SUBJECT: R.E. Ginna Nuclear Power Plant
Docket No. 50-244

Supplementary Response to Generic Letter 2004-02, "Potential Impact of Debris Blockage on Emergency Recirculation During Design Basis Accidents at Pressurized-Water Reactors"

REGNPP GL 2004-02 RAI RESPONSE

Figure 3.j.1.1: Planned Strainer Module Arrangement

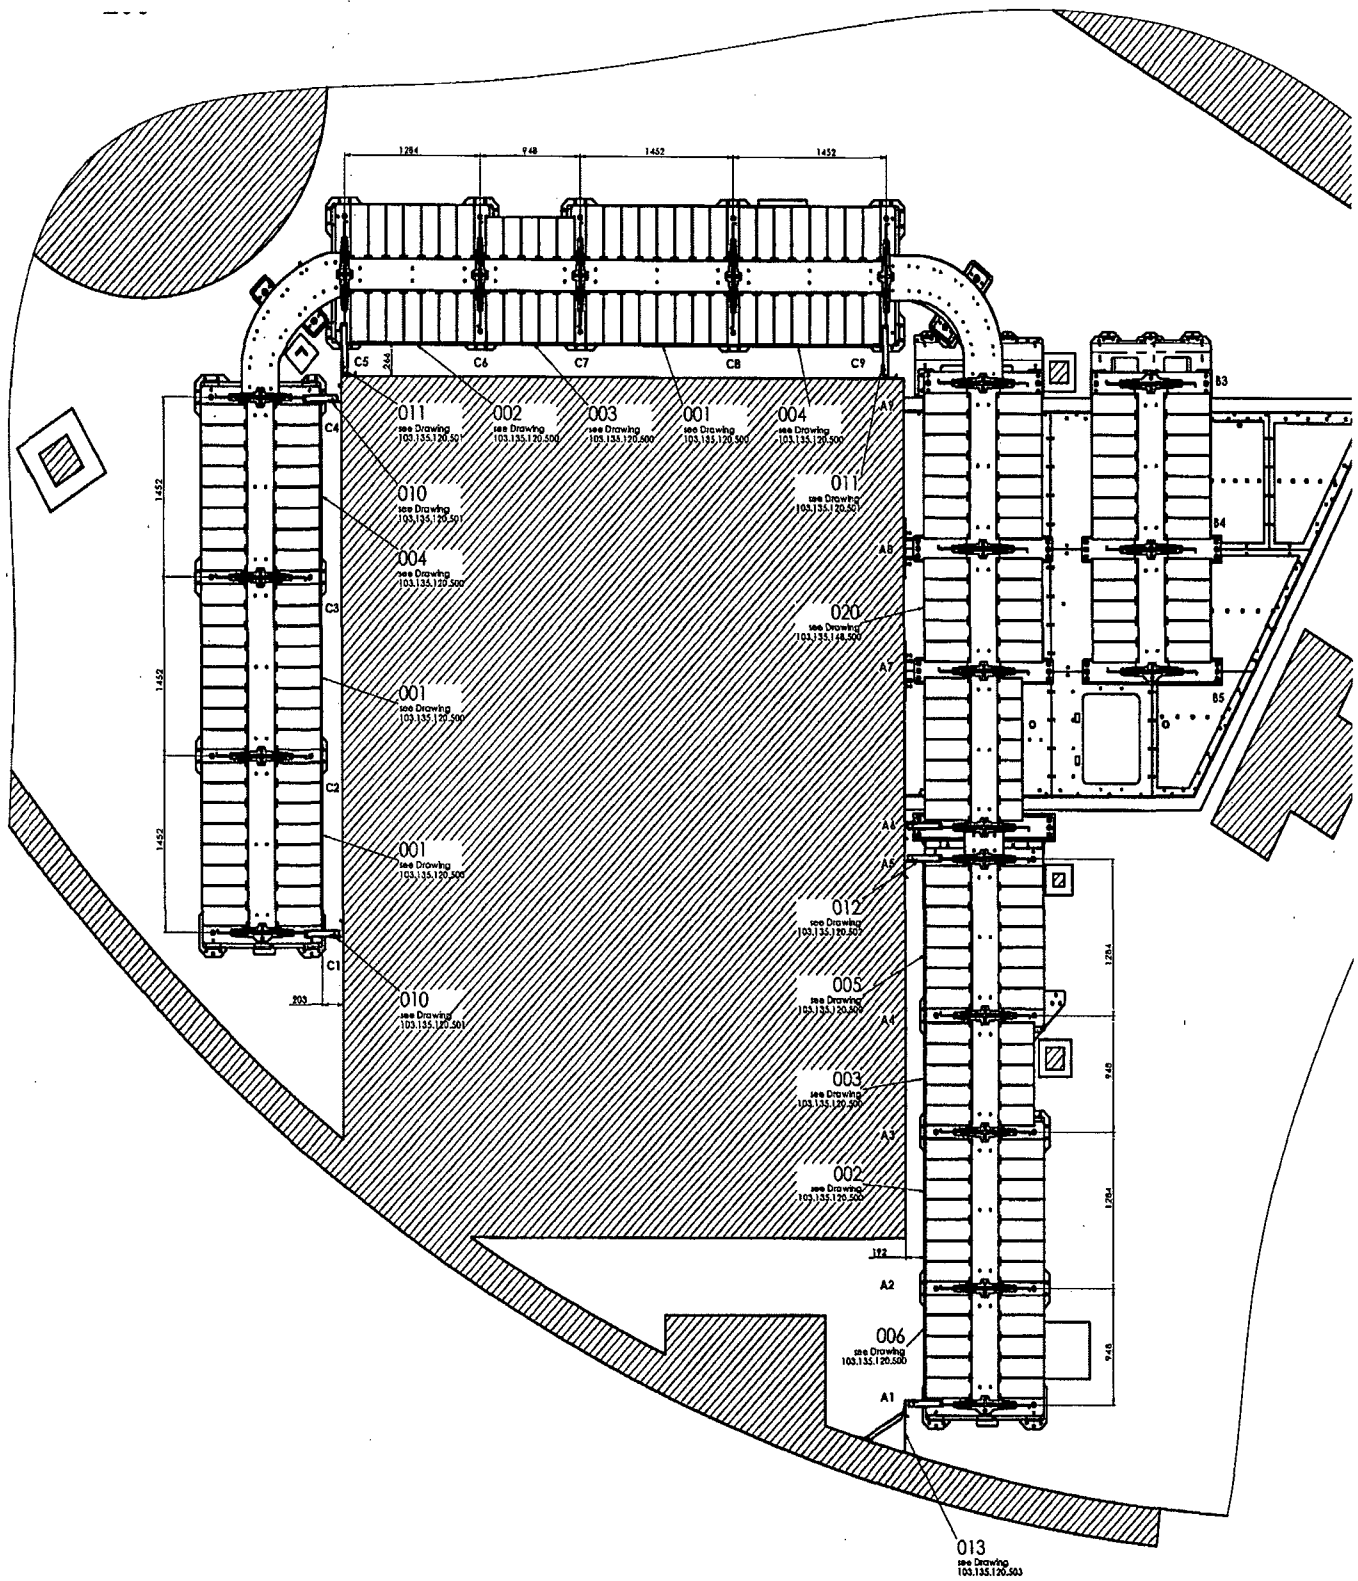
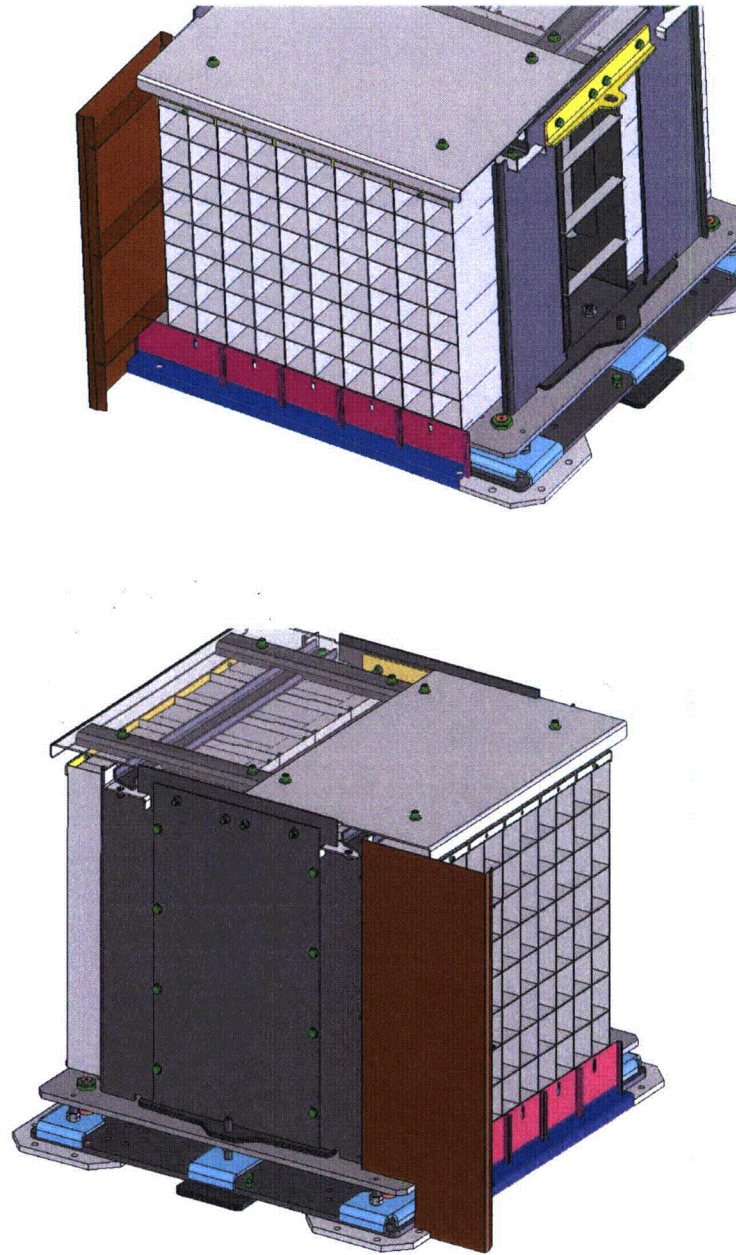
- 1. Provide a description of the major features of the sump screen design modification.*
- 2. Provide a list of any modifications, such as reroute of piping and other components, relocation of supports, addition of whip restraints and missile shields, etc., necessitated by the sump strainer modifications.*

The intent of the Ginna Sump “B” strainer modification is to perform the hardware change required to resolve issues presented in GL 2004-02 and GSI-191. This modification will be installed during the Ginna 2008 Spring refueling outage. The new design will replace an interim compensatory strainer design, installed during the Fall 2006 refueling outage, as part of the GL 2004-02 corrective action extension request approved by the NRC[i]. The interim strainer design added 600 ft² of passive sump strainer surface area. It also included a diverter wall installed in the containment basement in order to reduce the direct transport path of debris into the recirculation sump from a postulated break in the “B” reactor coolant system compartment. The interim strainer, diverter wall, existing sump screens and grating is planned to be replaced by a CCI designed and fabricated passive sump strainer with 4000 ft² of surface area.

Five of the 16 strainer modules will sit directly on the sump cover. Since the sump cover is approximately 6” above containment basement floor elevation, the height of these modules is adjusted to maintain the same overall height as the modules that are fixed to the basement floor. These 5 modules will direct the flow into the sump. To accommodate the increased weight of the modules on the sump cover, structural modifications are required [ii]. The existing 4” x 8” steel beams will be replaced to accommodate cross-bracing and ensure

With the addition of 16 strainer modules to the containment basement, some minor piping interferences result. A 3" waste disposal sump "A" pump discharge line on the north side of the refueling canal wall will be re-routed. Also, a 45 ft section of the 44" Containment Recirculation Fan Cooler air duct will be removed and capped. These modifications are to allow for improved access to the area in which strainer modules will be installed. Each modification has been designed in adherence to the design requirements for that system.
